Addendum #2 - Issued on October 23, 2012

Regarding Bids for **Engineer Road Maintenance Building Shell and Site Work (ITB 12-030P)** for Lucas County Engineer Road Maintenance, bid opening scheduled for October 26, 2012 at 2:00 P.M. (local time).

Lucas County Road Maintenance Building
Bid Package #12-030P – Shell & Site Work Packages
Dated 10/23/2012

ADDENDUM NO. 002

SHEET NO.
A1.01

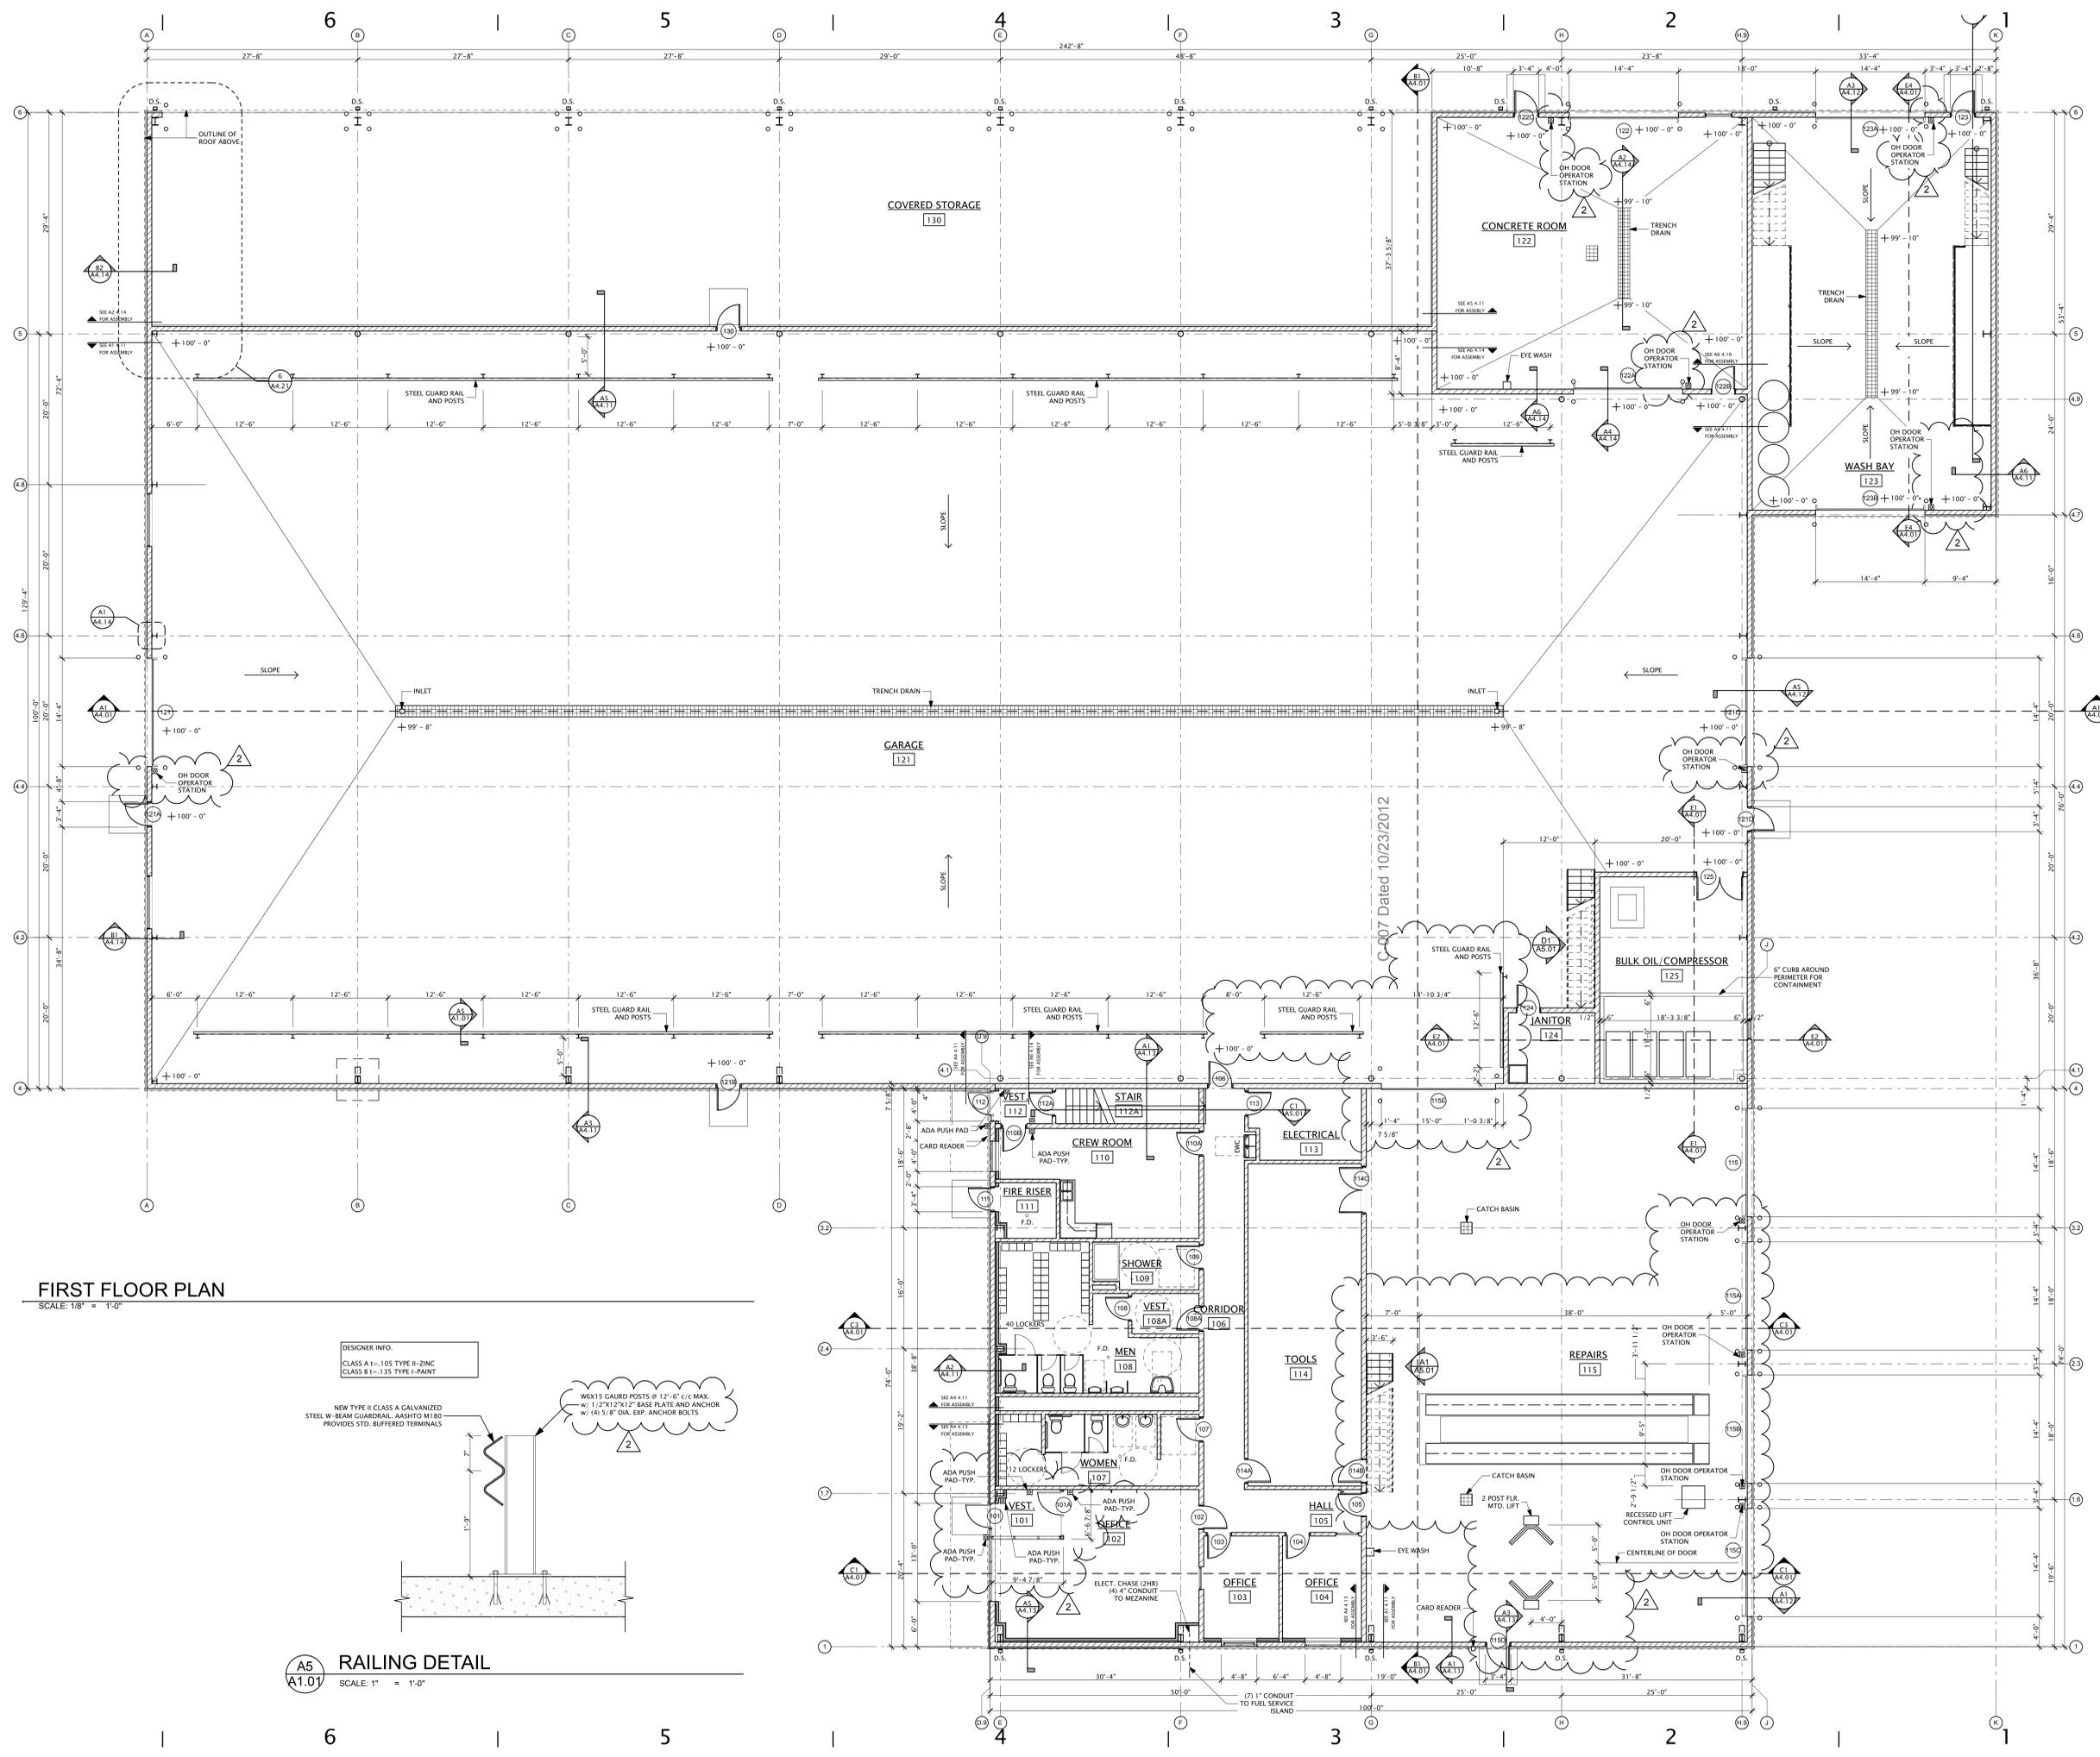
Answer: Control station locations have been added to sheet A1.01.

Answer: The entrance door 101 and adjacent storefront was intended to be a single unit and the vestibule associated with 101A as storefront framing, also. This has been revised to reflect construction intended. See attached written narrative and re-issued sheet A1.01.

Drawing A1.01 “First Floor Plan” – Re-Issued

Item #1 Added floor recess for vehicle lift equipment in Repair 115.

Item #3 Added insulated overhead door 115E.

Item #5 Revised entrance, storefront framing and vestibule framing associated with doors 101 and 101A.

Item #6 Added accessible push pad locations to doors 101, 101A, 110 and 110B.

A5 RAILING DETAIL
 A1.01 SCALE: 1" = 1'-0"

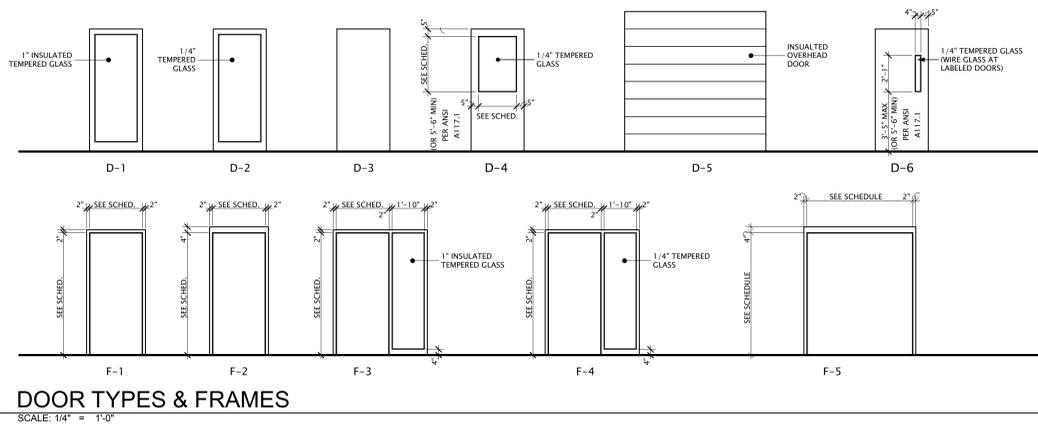
- m) (SHELL) Question: Sheet A1.01 – Highway Guardrail – Plan calls for posts to be 12'-6" on center. Detail A5 says posts are to be 8'0" on center. Verify

Answer: Detail A5 has been revised to required posts at 12'-6" on center.

WEX15 GUARD POSTS @ 12'-6" C/C MAX.
 W/ 1/2"x1 27"x12" BASE PLATE AND ANCHOR
 W/ (4) 3/8" DIA. EXP. ANCHOR BOLTS

SHEET NO.
A2.01

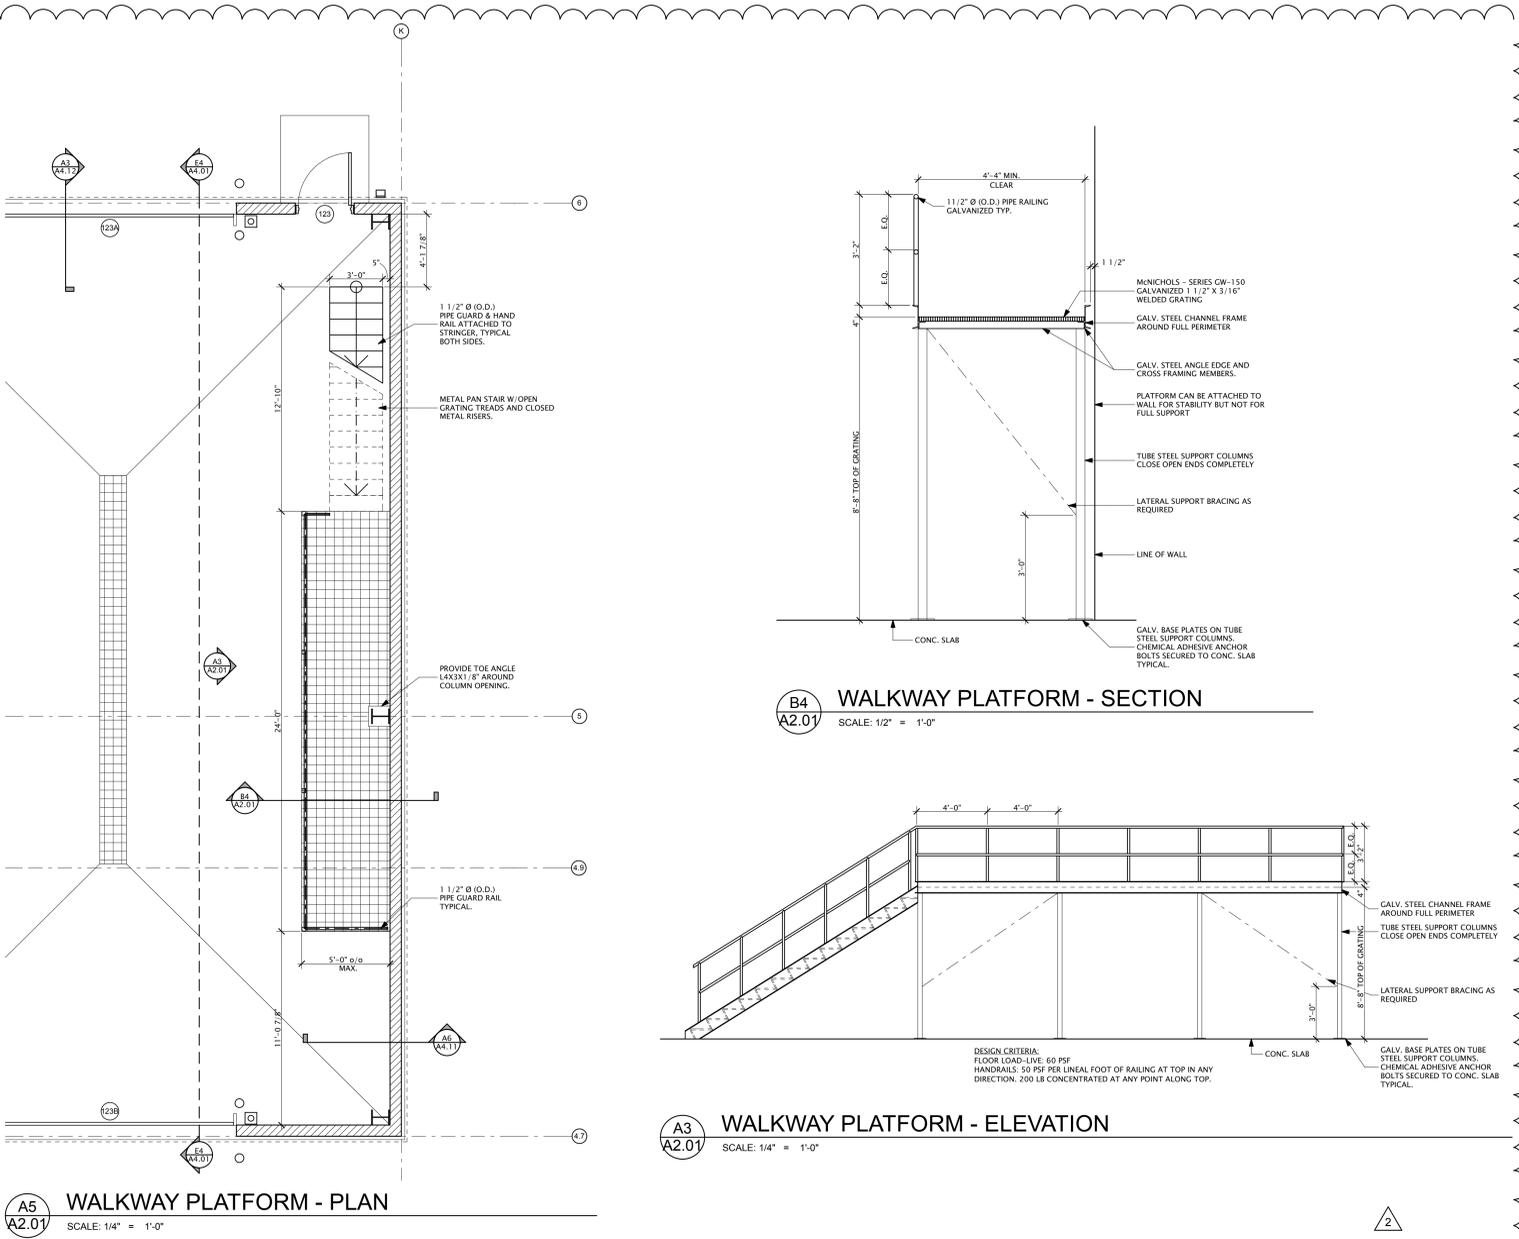
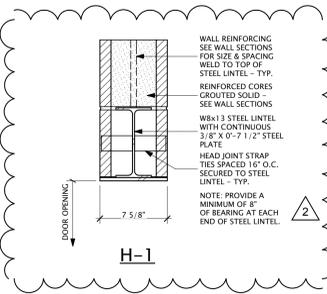
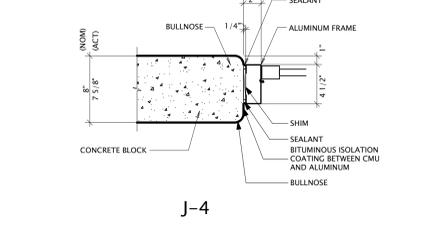
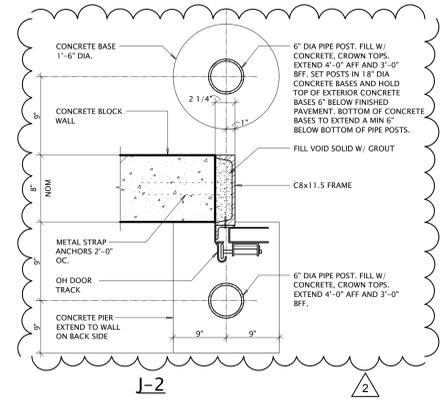
- i) (SHELL) Question: Need details for stairs and platforms in wash bay.

- k) (SHELL) Question: OH Door 122A is in an interior wall. I believe this should be an 8" channel door frame with lintel for a 14' M.O. Verify details.

Drawing A2.01 “Door Schedules” – Re-Issued

Item #1 Revised jamb detail “J2” bollard dimensions to agree with structural drawings.

Item #2 Added head detail “H-1” to drawing related to interior OH door 122A.

Item #3 Revised information related to door 115E; changed to OH sectional door.

Item #4 Added layout and information for delegated-design Wash Bay walkway platforms including design load criteria.

Answer: Stairs and platforms in Wash Bay design criteria as included in this addendum. Note that this fabrication is a delegated-design to comply with the criteria on the included sketches.

Answer: In reviewing the drawings, the Door Schedule indicates OH Door 122A to have an 8" steel channel door jamb. This addendum contains a sketch detailing the head condition and the steel beam and plate lintel size for the opening.

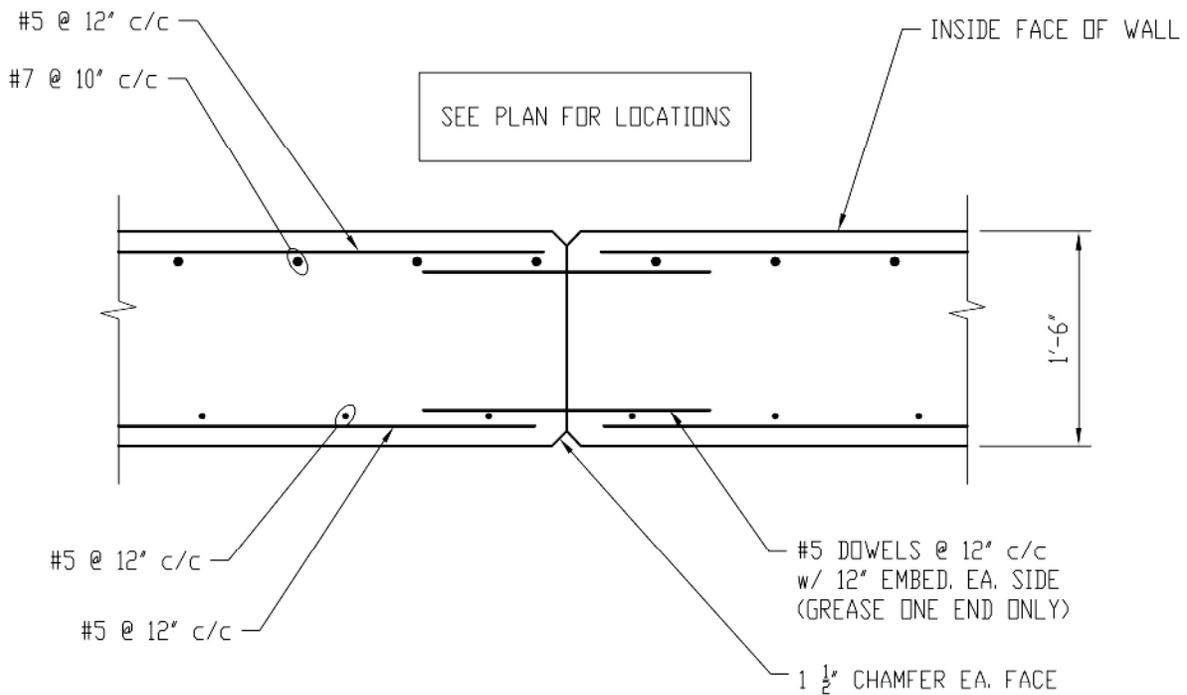
- f) (SHELL) Question: Need Lintel Schedule.

- x) (SHELL) Question: (Salt Barn) What is the required spacing of the concrete wall construction joints?

Sketch SKF-01 “LINTEL SCHED. & WALL CONTROL JT.” – New Issue

Item #1 Typical masonry lintel schedule for sized openings indicated.

Item #2 Typical control joint detail for salt barn wall construction.

Answer: Lintel schedule is included as a sketch with this addendum.

Answer: Refer to attached sketch for required construction joint spacing.

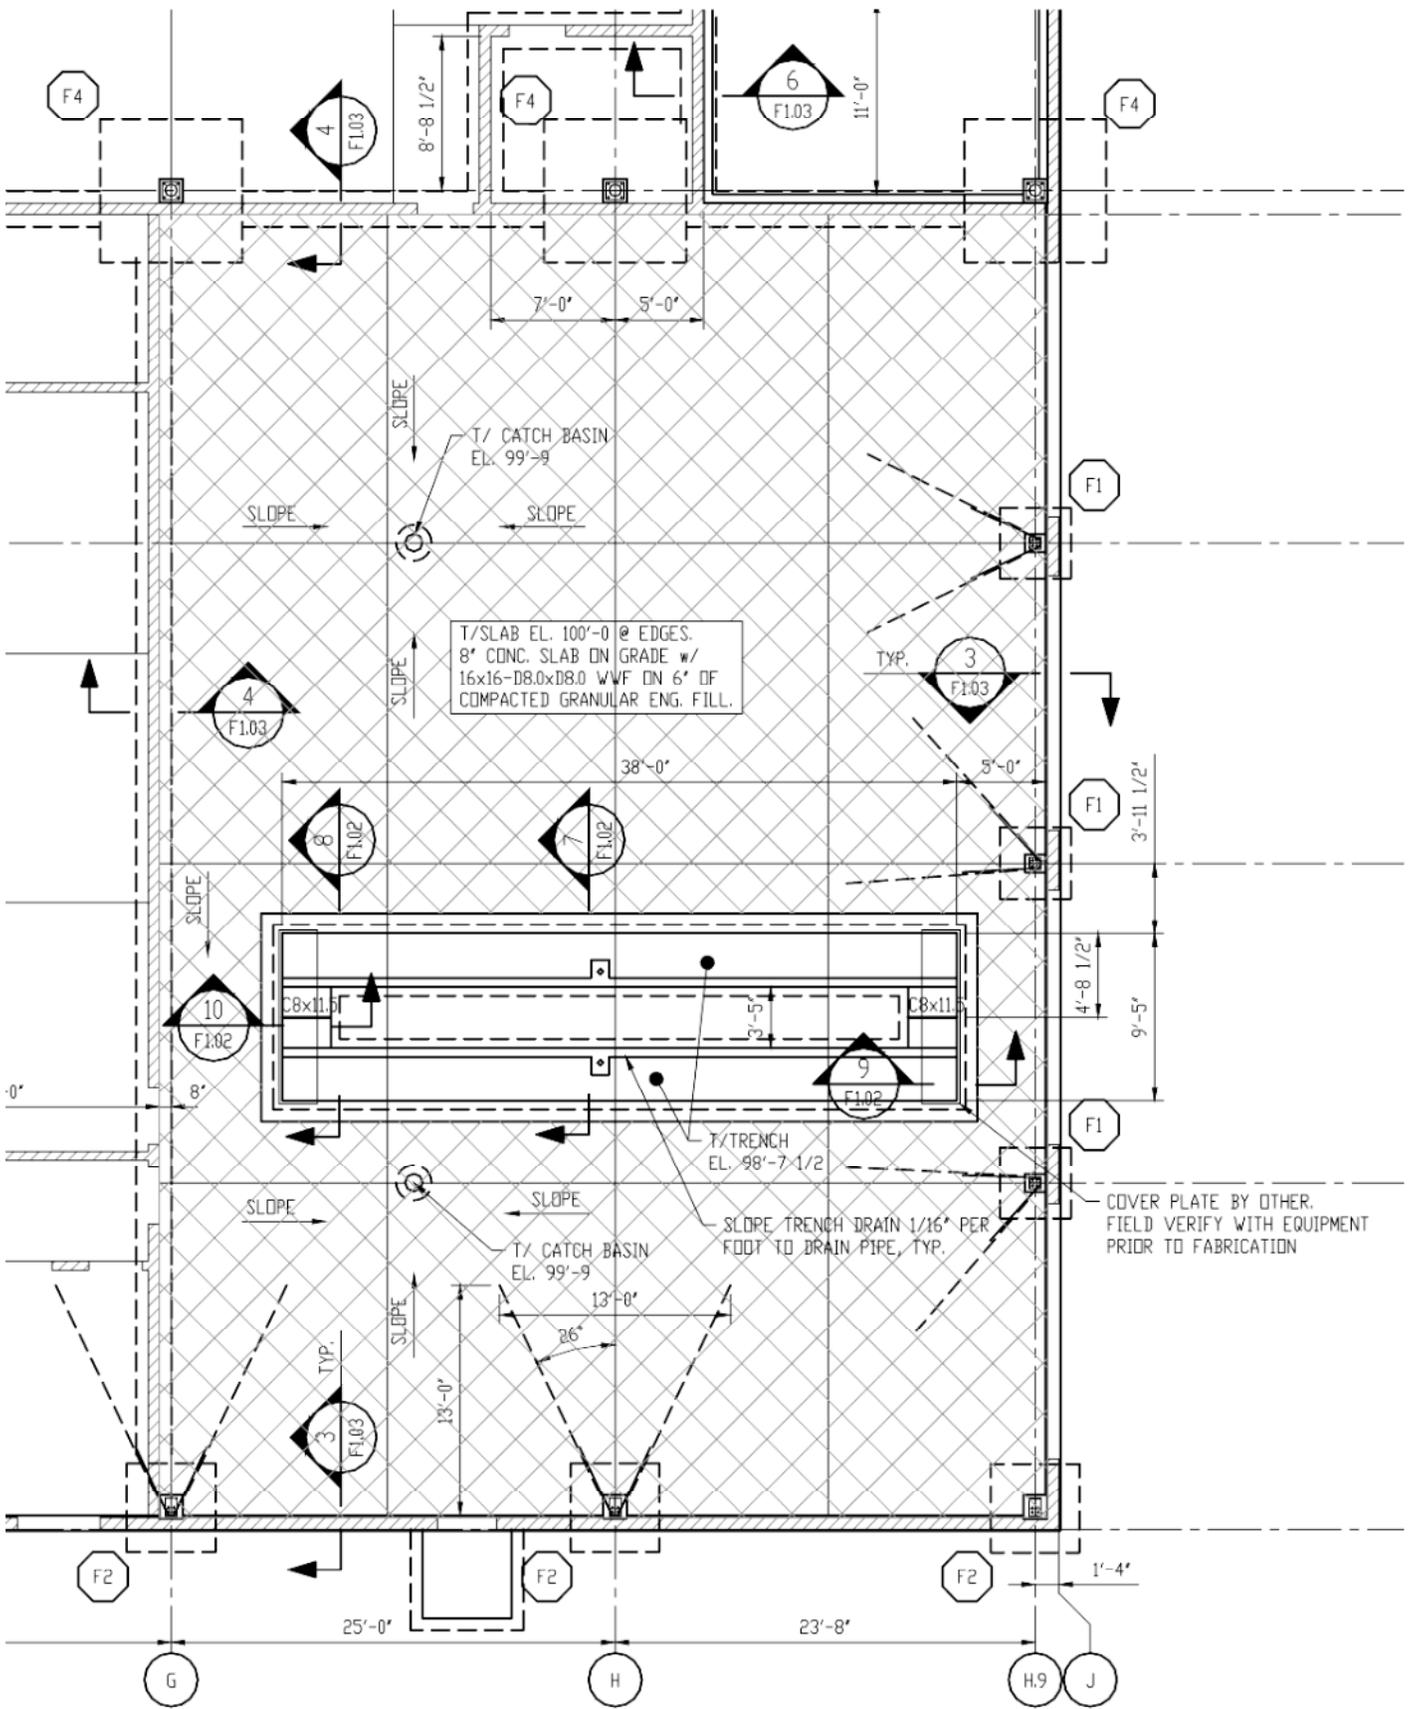
Sketch SKF-02 “LIFT PIT PLAN” – New Issue

Item #1 Plan layout for recessed pit in room Repair 115 for vehicle lift equipment.
